ADDENDUM NO. 2

Re: **ADDENDUM NO. 2– Intersection Improvements on Hastings and Wire Village Roads and Widening of Bridge S-23-010 over Turkey Hill Brook in Spencer, MA**

ABUTMENT ELEVATIONS

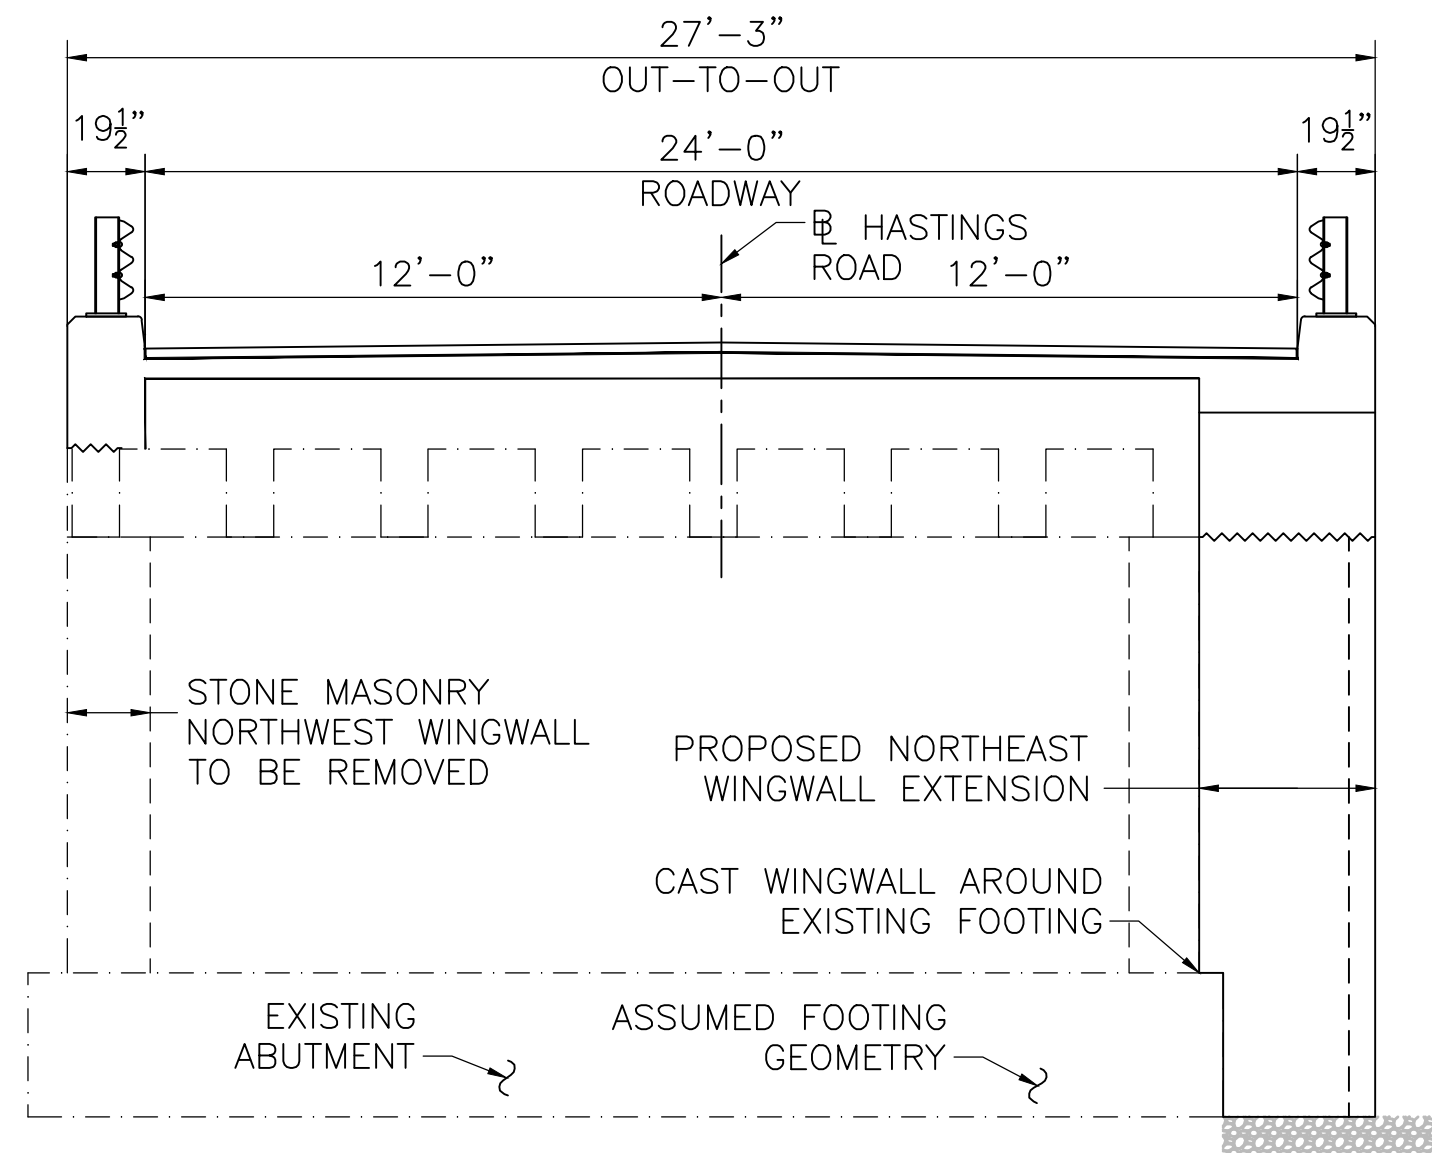
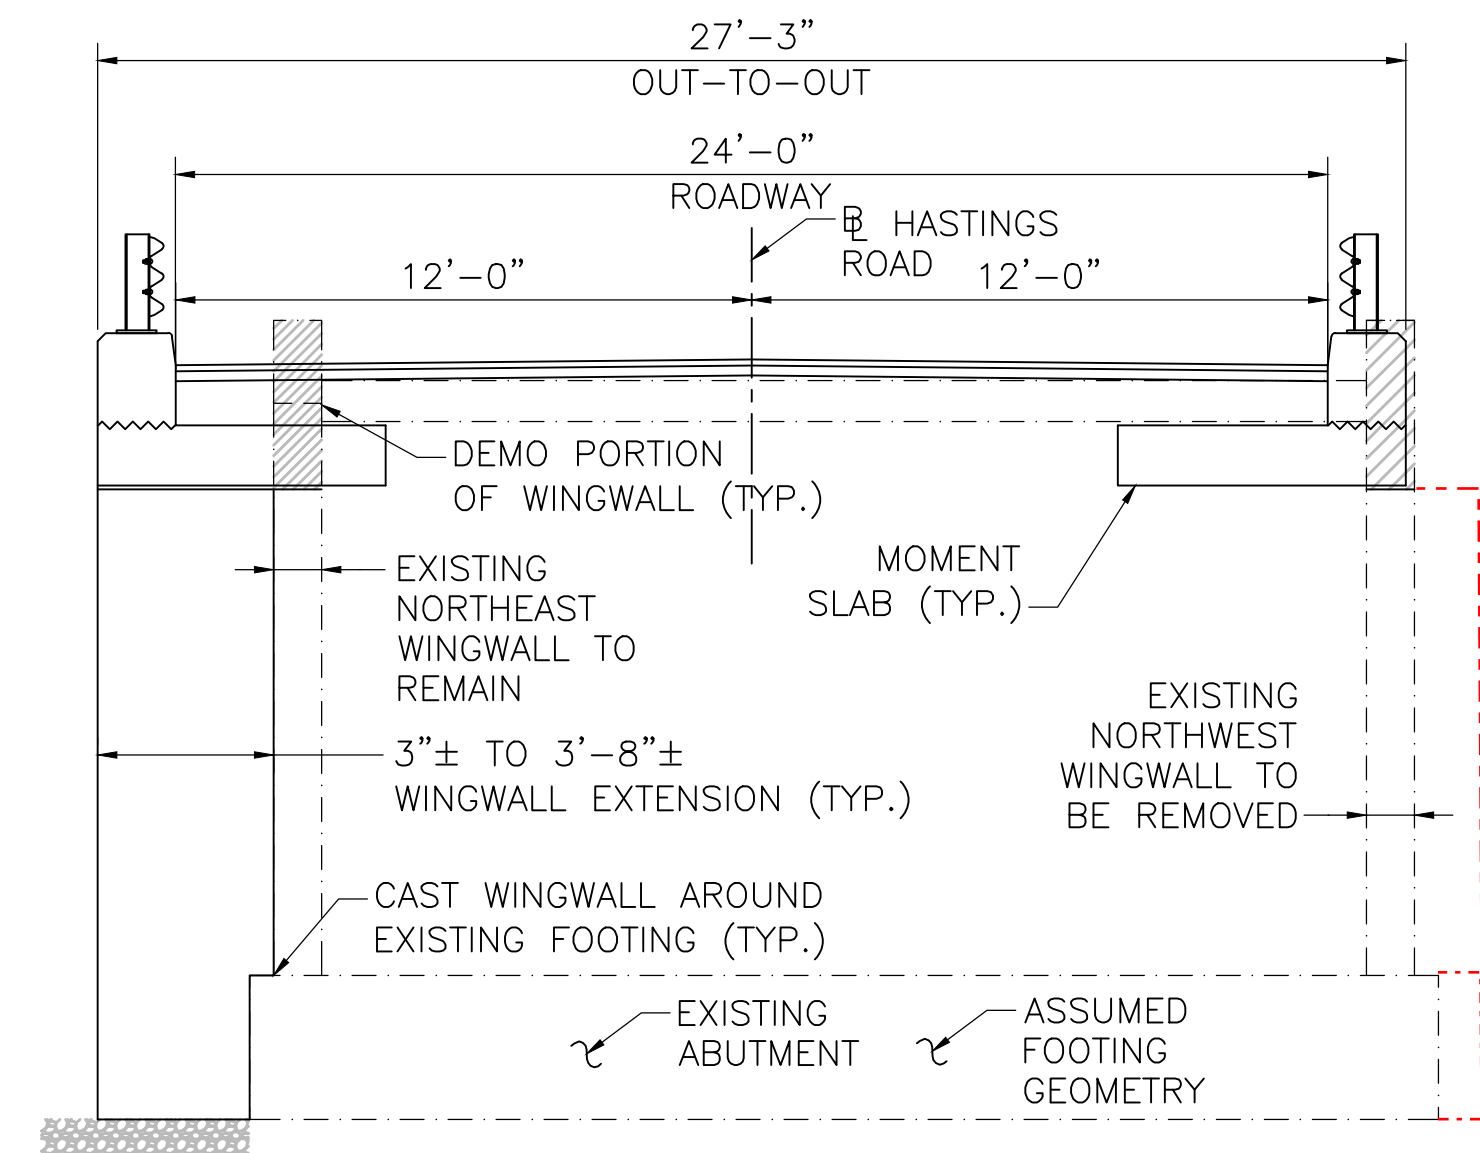
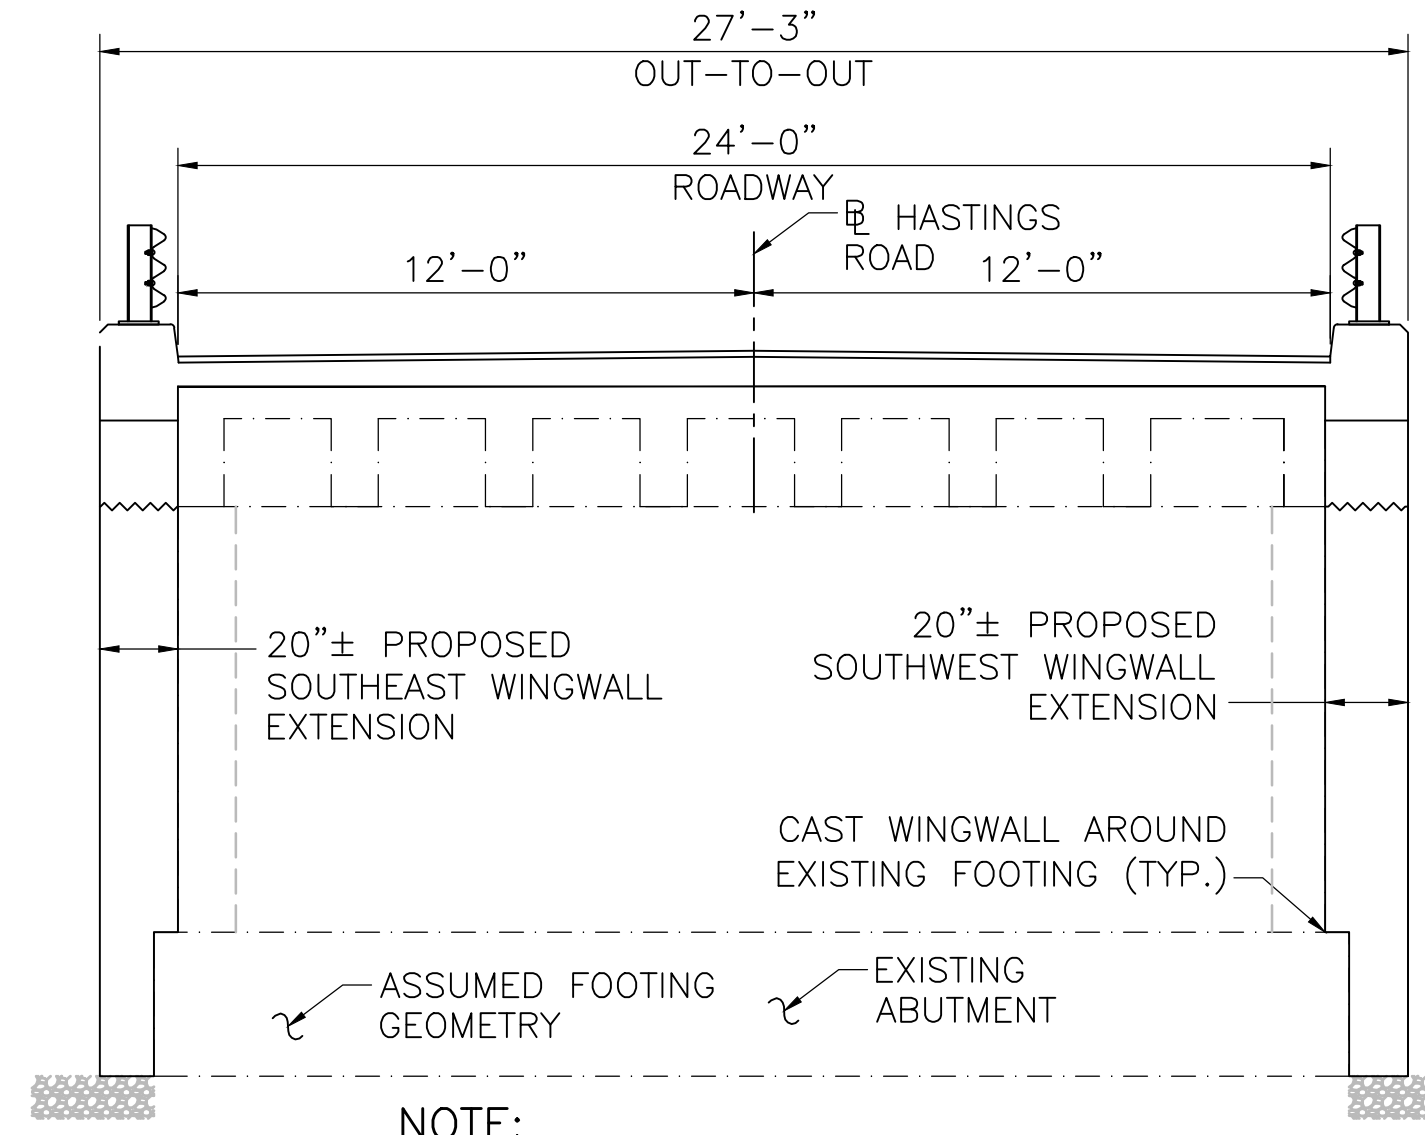
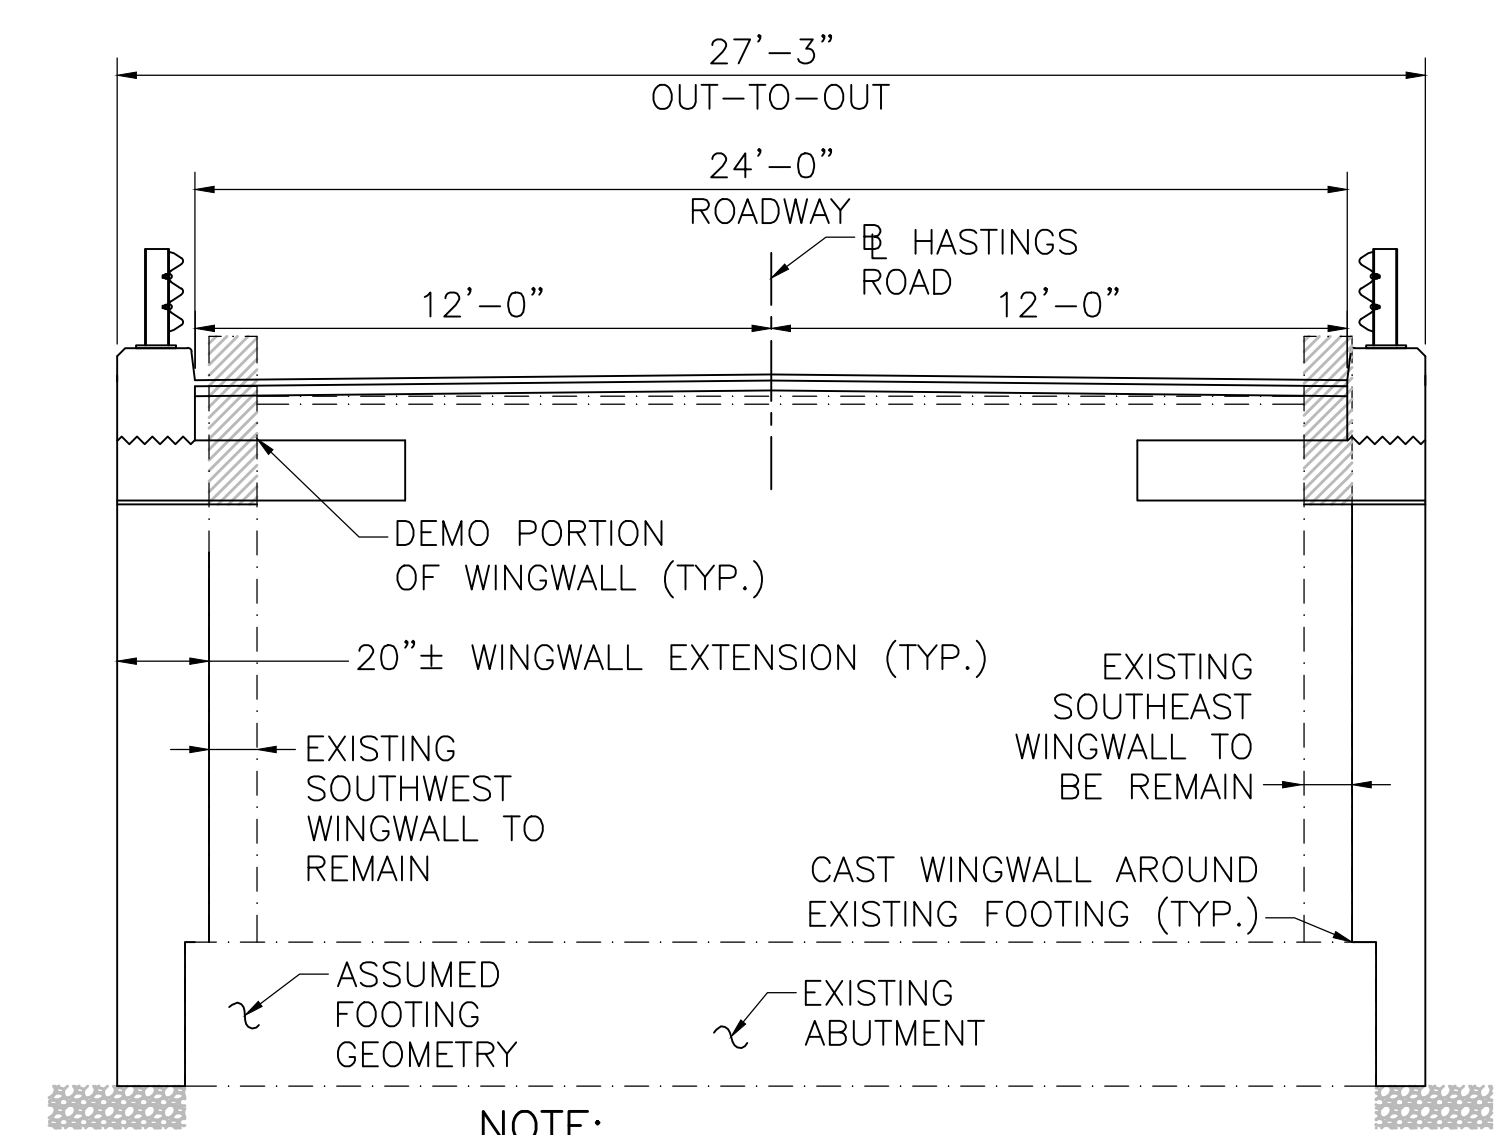
The elevations shown in the sections on sheet 6 of 12 do not seem to be correct. Please clarify.

Response: *Sections do need clarification on the direction of view. See attached markup which clarifies this along an adjustment to line work.*
